**AGENDA
PLANNING COMMISSION
CITY OF ROELAND PARK, KANSAS
ROELAND PARK
COUNCIL CHAMBERS
JULY 17, 2018 6:00 PM**

Date: 7/16/2018
Submitted By: Jennifer Jones-Lacy
Committee/Department: Admin
Title: **Rezoning and Redevelopment Plan for 5000 Johnson Drive Property**
Item Type: Presentation

Attached is the request to rezone and approve a preliminary/final development plan for 5000 Johnson Drive. The request is submitted by Kathy Warman of Warman Architects on behalf of the new building owner, Pride Cleaners. The request is to rezone the property to mixed use (MXD)

A1 PRELIMINARY ARCHITECTURAL SITE PLAN
SCALE: 1" = 10'-0"

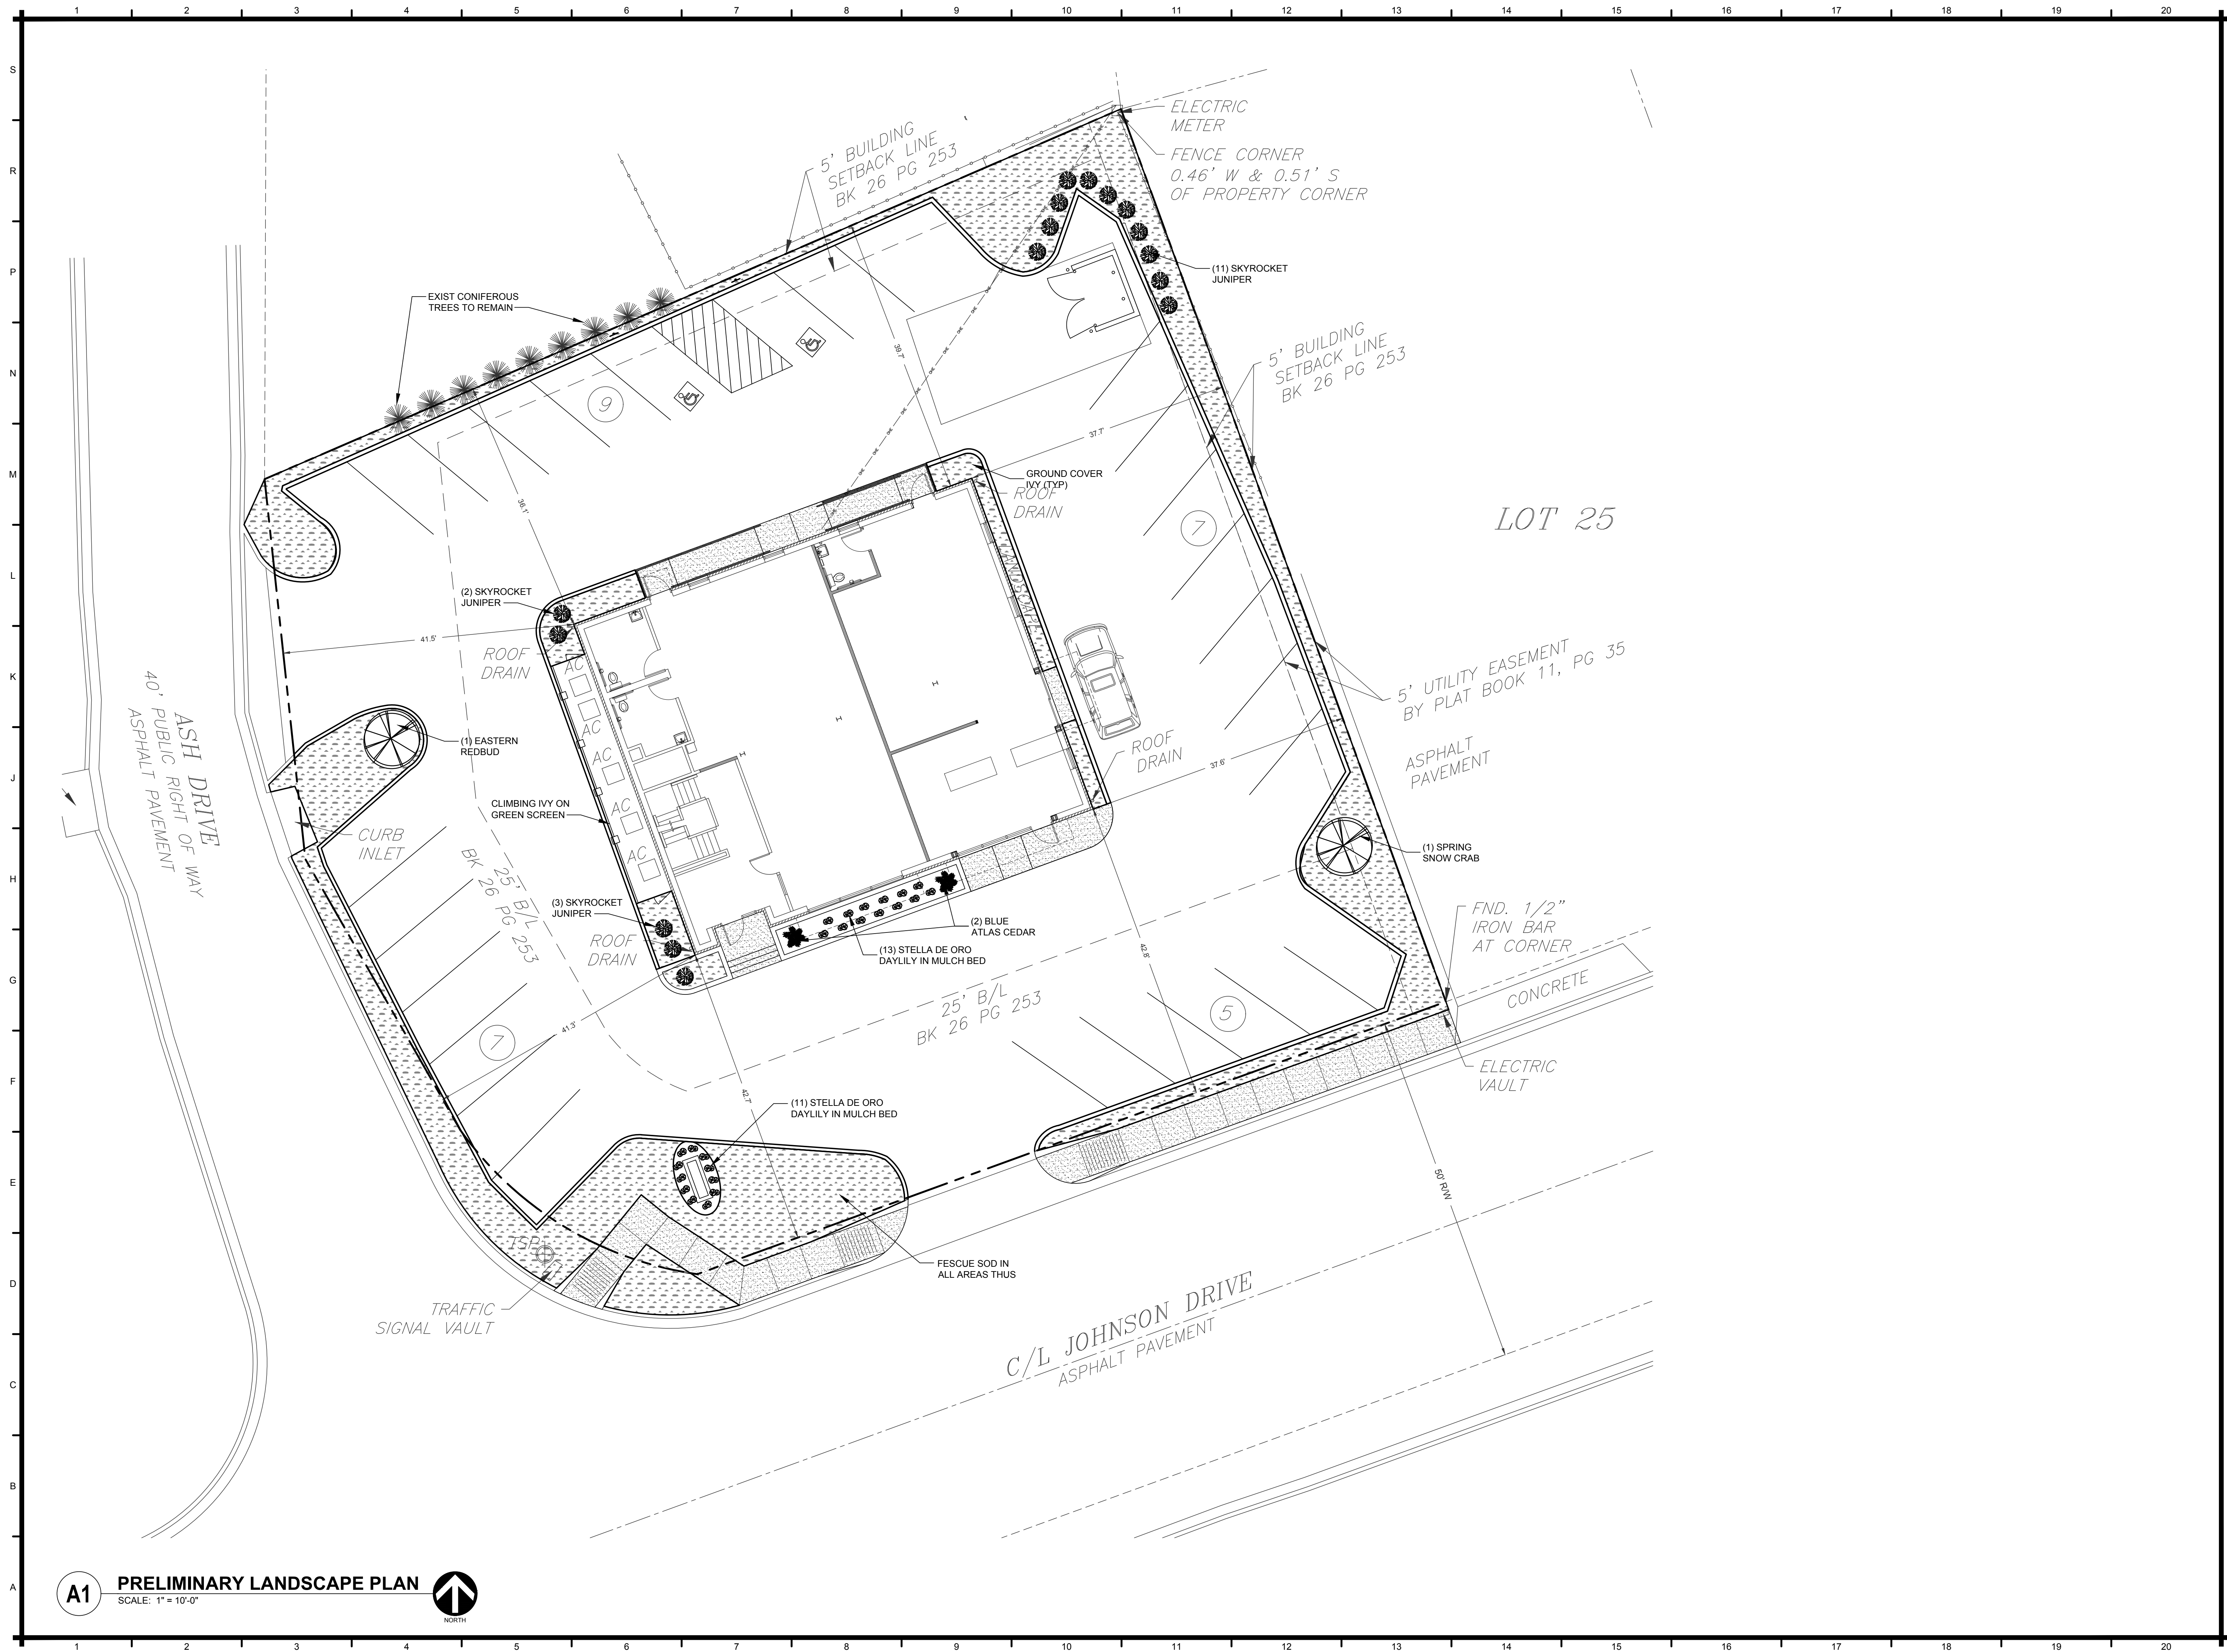
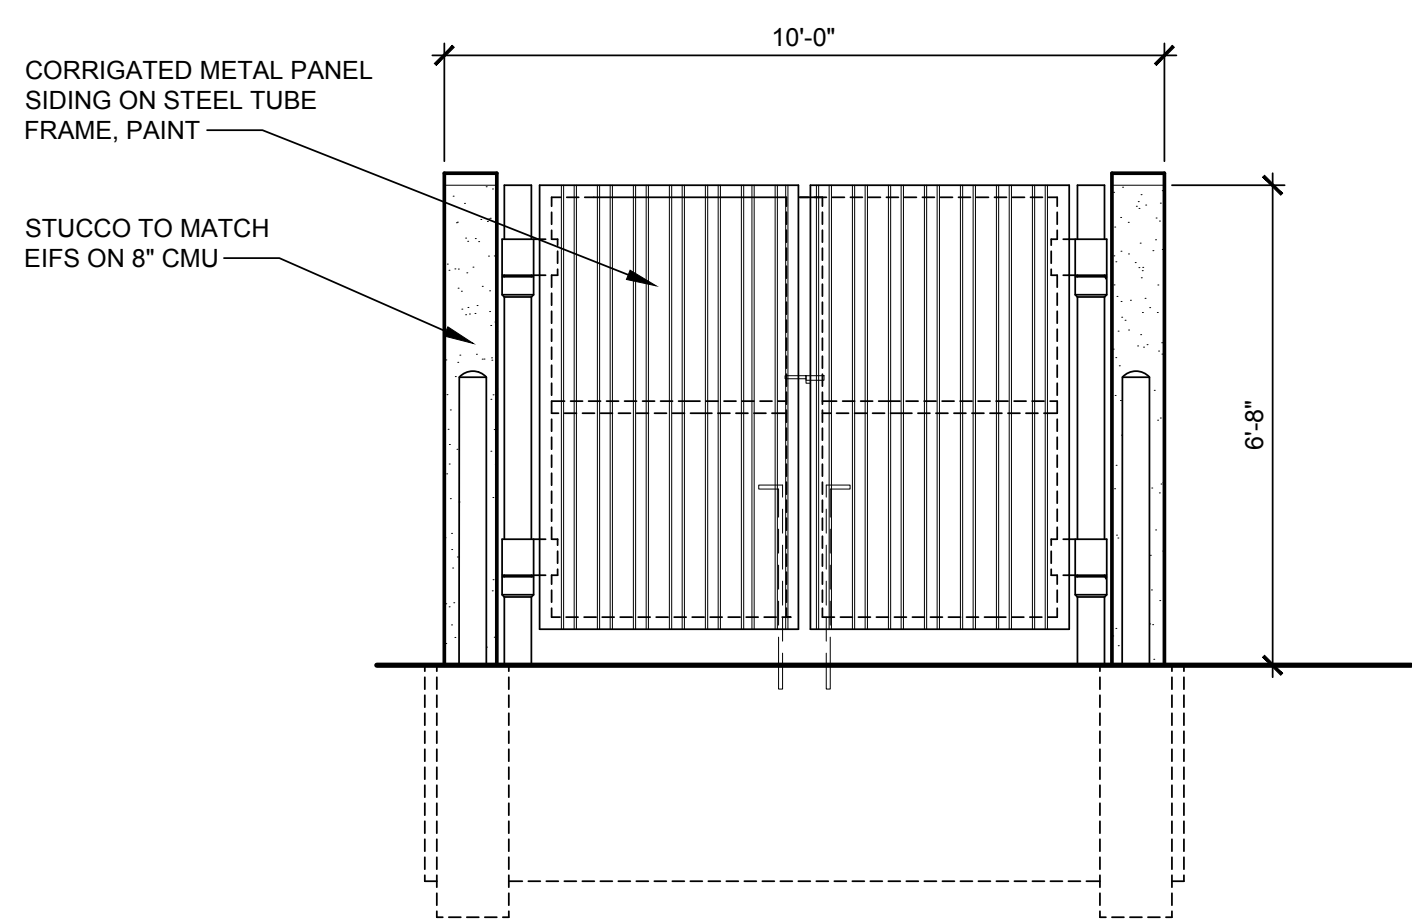
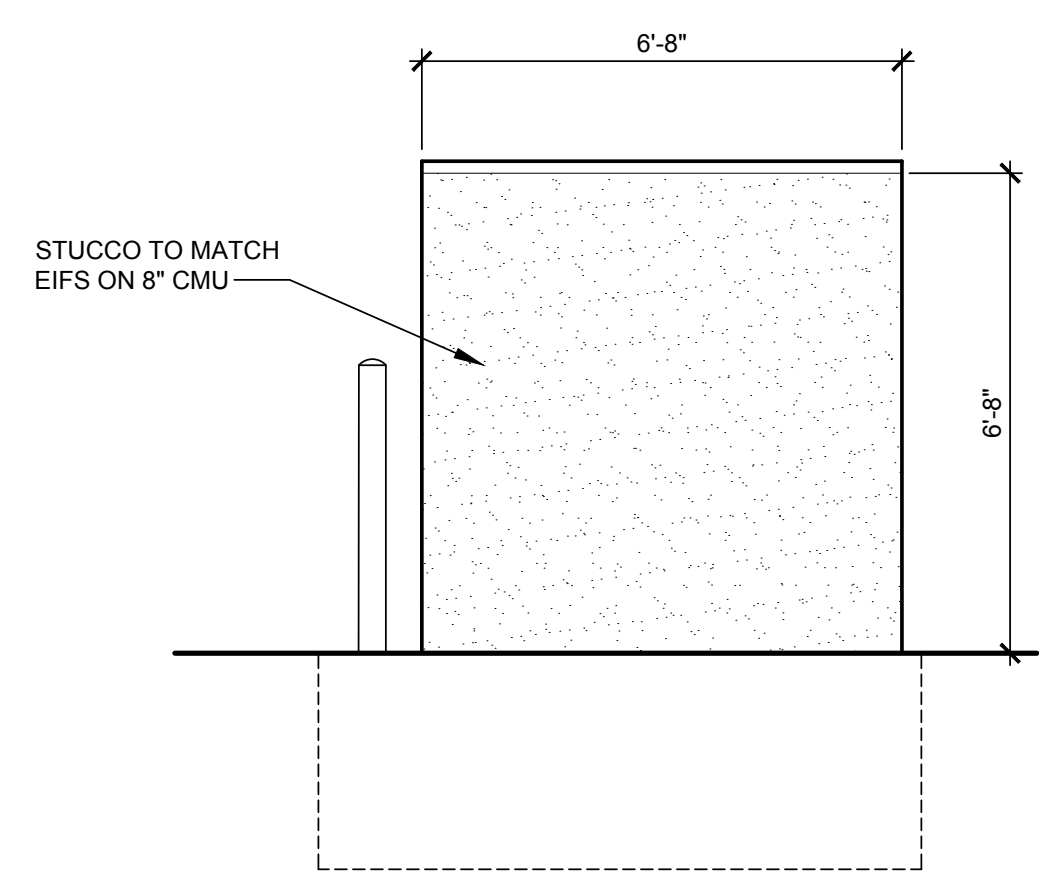
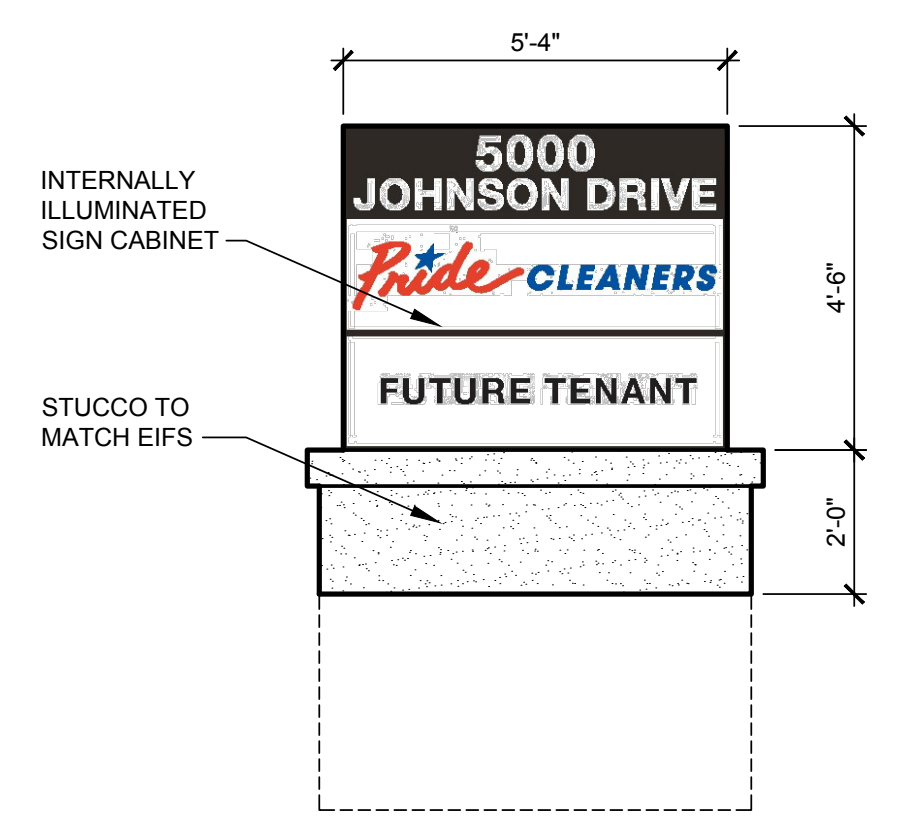
City Staff, the Mayor and Chair of the Planning Commission met with the applicant to discuss the proposed changes to the property. Staff made several recommendations to modify the original submission of modifications to the building and property. The details of those suggestions and the applicant's response are detailed below.

- **Add sidewalk fronting Johnson Drive:** Sidewalk has been incorporated
- **Relocate the condensing units to the roof and add plantings in this area:** The owner declined but provided screening via a "green screen" along the condensing units along with some evergreen shrubs
- **Replace Exterior Installation and Finish System (EIFS) with slate material on upper**

- **Painting of brick on lower level of the building:** Brick remains unpainted in the final submittal
- **Add canopy to south elevation:** The owner has complied with this request by adding metal awnings over both the north and south elevations and added new ADA compliant ramps and railing to the north entrances.
- **Add building signage above the the south canopies instead of a monument sign:** The applicant has elected to include signage above the canopies as well as include a monument sign.

building level: The owner has elected to employ EIFS.
